THREE MILE ISLAND NUCLEAR STATION, UNIT NO. 1

AMENDMENT TO FACILITY OPERATING LICENSE

Amendment No. 79
License No. DPR-50

ATTACHMENT TO LICENSE AMENDMENT NO. 79

FIGURE 6-2

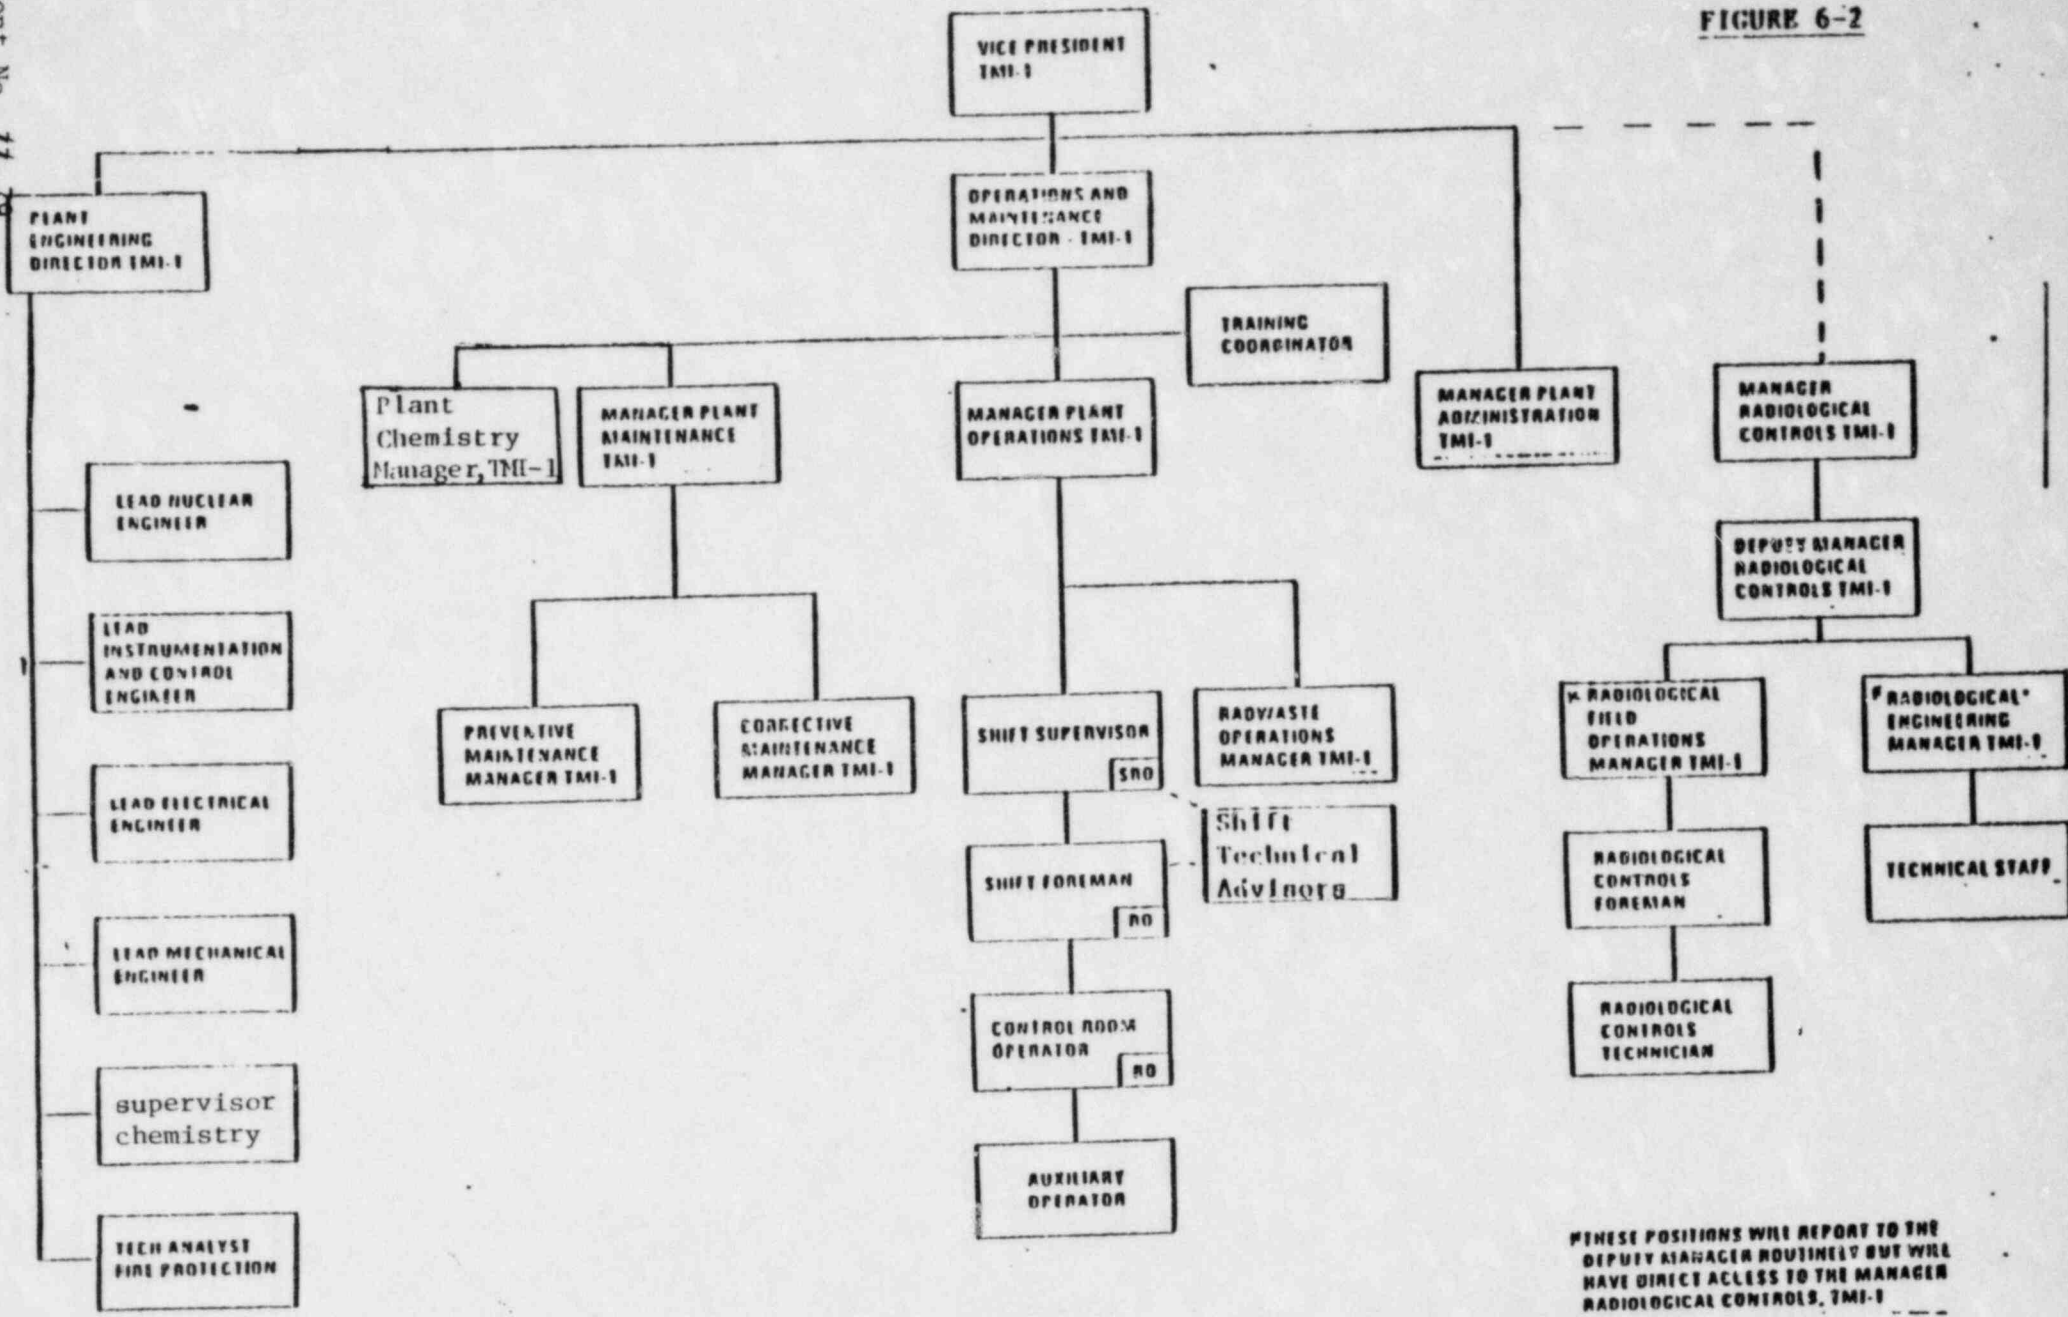
THESE POSITIONS WILL REPORT TO THE DEPUTY MANAGER ROUTINELY BUT WILL HAVE DIRECT ACCESS TO THE MANAGER RADIOLOGICAL CONTROLS, TMI-1
